# Responses to Reviewer Comments on “Effect of tip spacing, thrust coefficient and turbine spacing in multi-rotor wind turbines and farms”

## 1 Response to Reviewer 1

## 2 Response to Reviewer 2

Figure 1: Added turbulence intensity  $\Delta I_{disk}$  for isolated 1-rotor and 4-rotor turbines with varying tip spacings denoted in the label, for  $C'_T = 4/3$ .

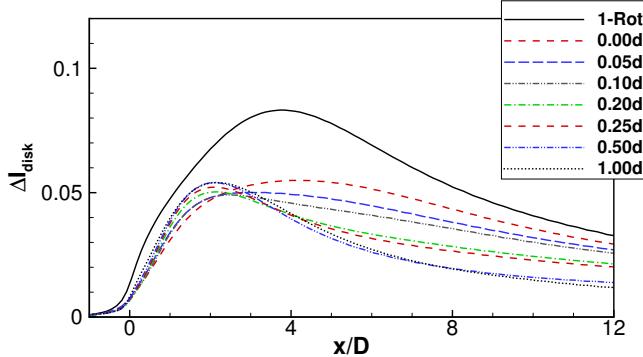
*When I looked at the integrated added wake turbulence intensity, I found that the four-rotor wind turbine has a higher integrated added wake turbulence intensity in the near wake compared single-rotor wind turbine, while the opposite is found for the far wake, see Figure 18 in van der Laan et al. (2019).*

**Response:** This is an interesting observation, that is not reproduced in our LES. It should be noted that the quantities plotted in our Fig. 6c and in Figs. 18(b,d,f) in van der Laan et al. (2019) are different. For a fair comparison between the two sets of results, the disk-averaged added turbulence intensity, defined as

is plotted in Figure 1. The subscript ‘disk’ denotes disk-average and the subscript ‘0’ denotes upstream region, or the region between  $x/D = -4$  to  $x/D = -1$  in our simulations, where the quantities are almost constant. This measure of added turbulence intensity is compared to Figs. 18(b,d,f) of van der Laan et al. (2019).

It is seen that  $\Delta I_{disk}$  for all the 4-rotor cases is always smaller than for the 1-rotor case. The qualitative differences between the near-wake and far-wake regions are not observed in our LES results. A closer examination of the results in van der Laan et al. (2019) suggests that  $\Delta I_{disk}$  is larger for the 4-rotor case in the near-wake region only for  $I_{ref} = 5\%$  and  $10\%$ , but not for  $I_{ref} = 20\%$ . Thus, our results may be considered to be qualitatively similar to the results of van der Laan et al. (2019) for  $I_{ref} = 20\%$ . It is difficult to gauge the accuracy of one LES with another LES as a benchmark, so we refrain from commenting on which LES result is more accurate. This information is included in Fig. 6(d) of the revised manuscript and in Section 3.2 (lines 218-224).
